Determination 2018/039

The code compliance of a walk-in shower to an ensuite in a 5-year-old house at 565 Maronan Road, Ashburton

Figure 2: Simplified sketches of shower junctions

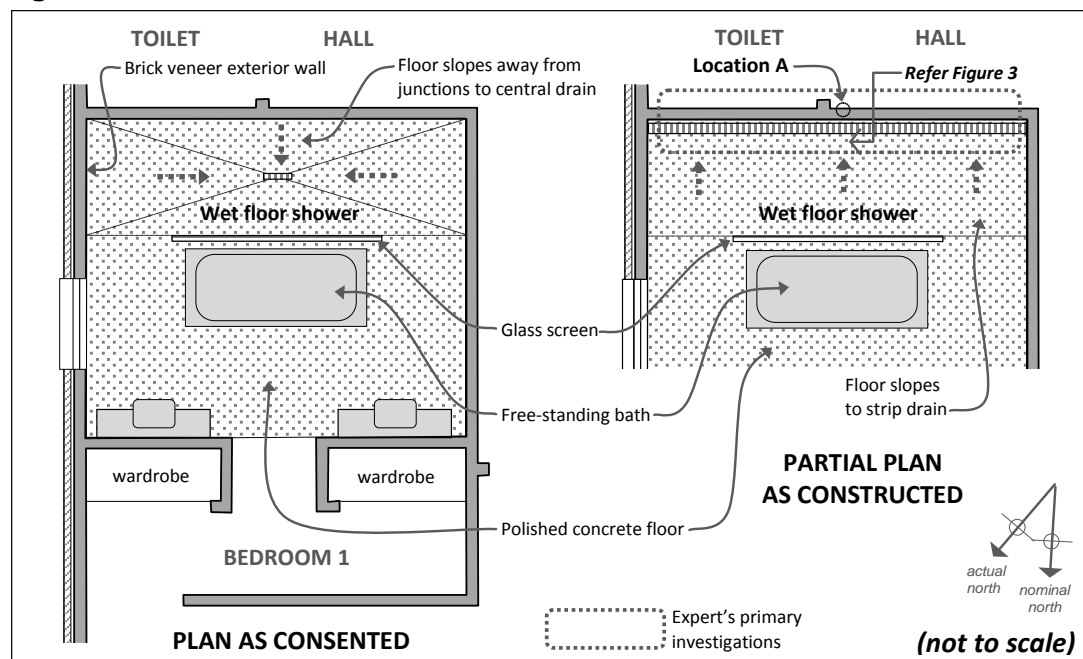
- 2.4.2 The shower is located adjacent to the south wall of the ensuite, with a glass screen separating the shower area from a free-standing bath. The floor is polished concrete and the walls are tiled. Although consent drawings showed the shower floor falling away from wall/floor junctions towards a central drain, the shower floor was constructed with a slope towards a strip drain positioned adjacent to the south wall as shown in Figure 1.
- 2.4.3 Figure 2 shows junction details in the consent drawings and compares these to the as-built junctions. The expanded detail [I] shows the junction, while details [II] show the expanded junction as described by the applicants and as observed by the expert.

- 6.1.1 The authority did not inspect the shower substrates and membrane installation during construction and is also concerned the consent details have changed and the concrete nibs around the bathroom were not constructed (see Figure 2).
- 6.1.2 The authority is concerned the ensuite bathroom does not meet certain functional and performance requirements of Clause E3 Internal moisture and Clause B2 Durability. The question is therefore whether, as installed, the shower lining complies with the relevant requirements of Clause E3 to the extent required by Clause B2.

- 6.2.3 In regard to the south wall/floor junction, as shown in Figure 2, I note the following:
- It appears the shower has only been in use for a limited period of time and only limited account can be taken of its present performance in use.

- Although the drain is adjacent to the south wall/floor junction, it is positioned within the floor topping slab and is separated from the junction. However, the location of the drain means water is directed towards the south wall.

- There is no reinforcement of (or detailed information about) the membrane at the junction of the vertical face of the concrete foundation slab and the plasterboard above. These are very dissimilar materials subject to the normal construction tolerances, and the timber frame to which the plasterboard is fixed will be subject to movement from variations in moisture content. This junction is critical to the performance of the shower membrane.

- The 30mm overlap of the floor and wall membranes is small.

- The membrane upstand may have suffered damage when the shower floor concrete was polished but whether this has occurred is not known. No information has been provided that records how the membrane was protected during the polishing of the concrete floor.

- The aluminium angle at the wall/floor junction is fixed onto the shower floor concrete.
- Water is able to access the tiling adhesive at the rear of the tiles at the gap between the tiles and the aluminium angle at the base of the wall, and will also be drawn into any gap between the angle and the floor.

- 5.4.1 The expert considered BRANZ guidance on similar junctions and noted several wall/floor junctions that include sealant at the joints.
- 5.4.2 Taking account of the minimal amount of moisture ingress at the shower wall/floor junction, the expert considered a bead of mould-inhibitive sealant applied to the gap would likely prevent moisture penetration, although this would require regular maintenance to remain durable.

Figure 1: The ensuite bathroom

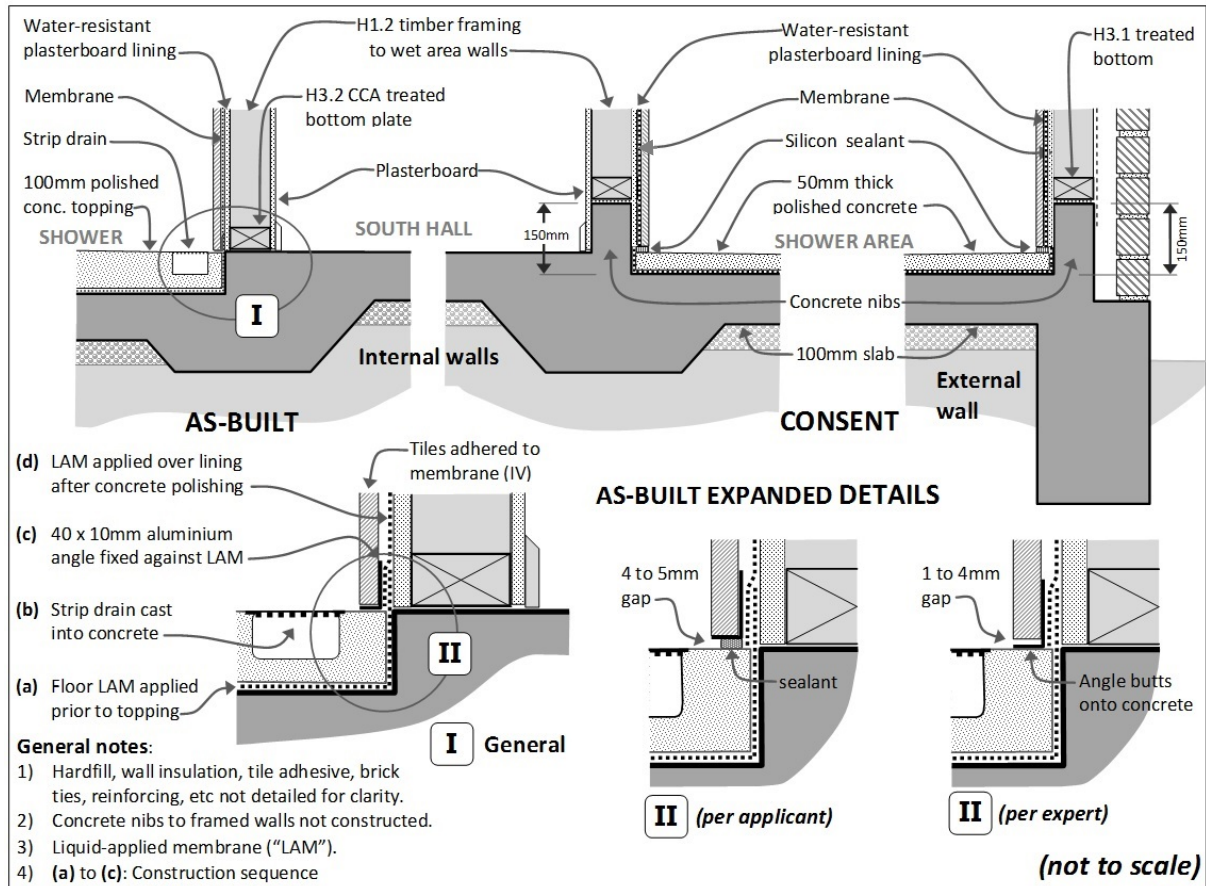
- 2.4.1 The ensuite bathroom is shown in Figure 1, with the partial as-built plan highlighting the south wall as the focus of the authority's concerns and the expert's investigations.

- 5.3.2 The expert investigated the south wall of the ensuite by removing skirtings and 7 small cut-outs of lining from the adjacent hall and toilet (see Figure 1), observing:

- no evidence of mould on the back of shower plasterboard.
- 5.3.3 The expert took surface readings on the back of shower plasterboard just above the bottom plate and obtained consistent results from three different moisture meters. Readings were ‘well within an acceptable range’, except for one area towards the toilet door which was ‘slightly elevated at 17%’ (see Figure 1, Location A).

- 5.3.4 The expert drilled 80mm into the bottom plate and took invasive readings close to the shower plasterboard and noted a similar pattern to the above; with readings ‘well within an acceptable range’ except for the same Location A, which had a moisture level of 18% (when corrected to account for CCA treatment). The expert also noted the moisture readings dropped to below 16% some 100mm away from Location A.
